IOWA DOT	REVISION	
	16	10-21-14
	STANDARD ROAD PLAN	
RF-19E		SHEET 1 of 1

**OUTLETS
FOR LONGITUDINAL, TRANSVERSE
AND BACKSLOPE SUBDRAINS**

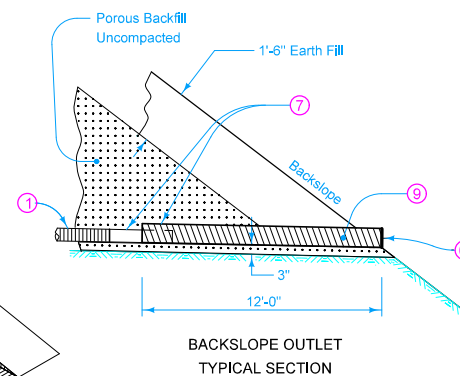
REVISIONS: Revised circle notes 7 and 9. Added circle notes 11 and 12. Changes made to include material from Materials I.M. 443.01.

- ⑦ If metal pipe is used, the pipes should be coupled in one of the following ways: (1) Use an inside fit reducer coupler (coupler must be inserted a minimum of 12" into CMP); or (2) Insert 12" of the 4" subdrain into the 6" metal outlet pipe, then fully seal the entire opening with grout.

- ⑧ Bevel the trench to provide a minimum of 3" of porous backfill surrounding all portions of subdrain pipe.
- ⑨ Corrugated metal pipe outlet 2" larger than existing subdrain pipe, or corrugated double-walled PE or PVC pipe of the same diameter as the existing subdrain pipe.

- ⑩ Place class 'A' crushed stone or Special Backfill over outlet and carefully compact to avoid damaging outlet pipe.
- ⑪ Minimum 2" if attached to double walled PVC. Minimum 3.75" if attached to corrugated metal pipe.

- ⑫ Minimum 0.09" thick metal ring. Minimum 17 gauge (0.054") expanded sheet metal grate. Expanded sheet metal may be either flattened or standard.
